#### FINAL WATER & WASTE WATER BASIS OF DESIGN REPORT

## FOR WILSHIRE TOWN HOMES 7121 E. WILSHIRE DRIVE, SCOTTSDALE AZ 85251 APN 129-05-010D COS Case # 11-DR-2017

FINAL Basis of Design Report

Exhibit 3 Site Utility Plan for Wilshire Place Townhomes

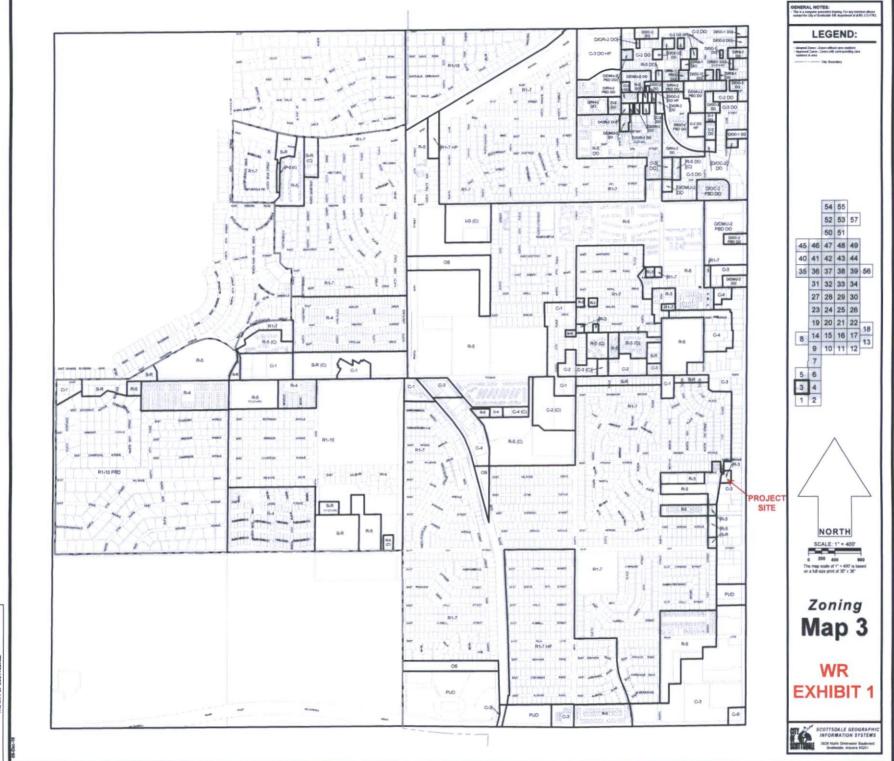
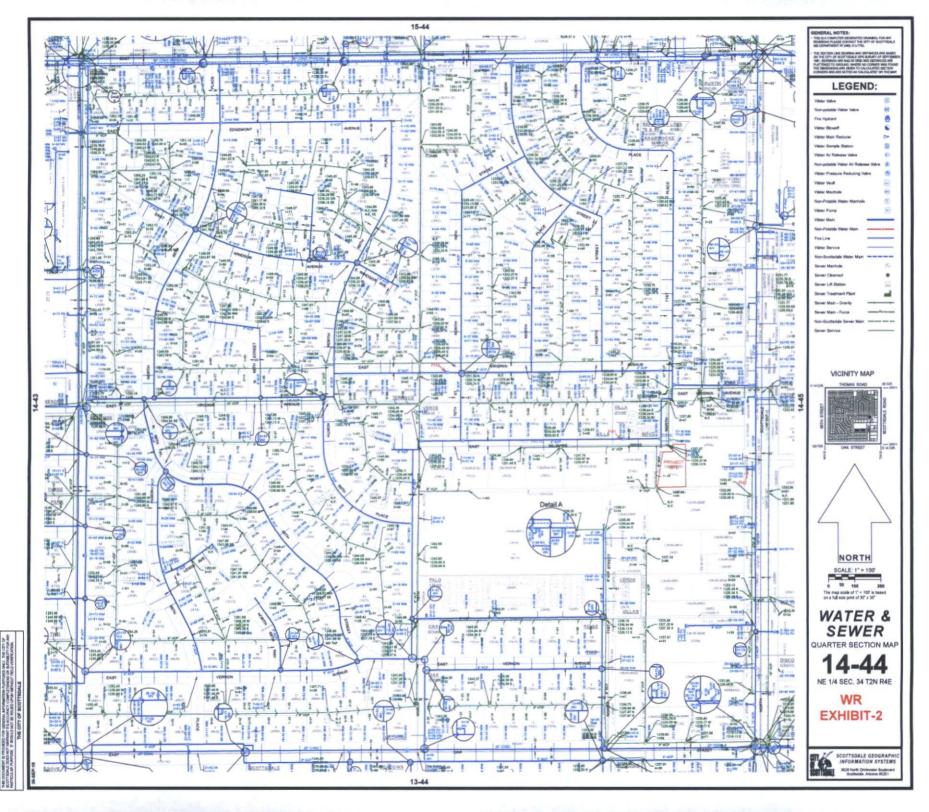
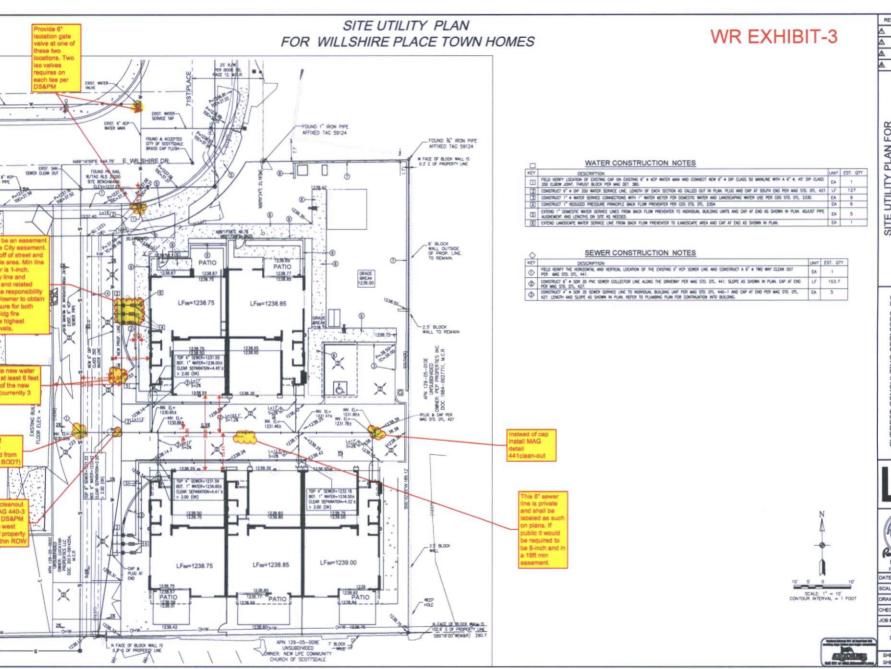
For improvement plan submittal address all comments shown on utility plan herein (second to last page). 7555 S. Parkcrest St. Gilbert, AZ 85298 Tel: 623-533-0334
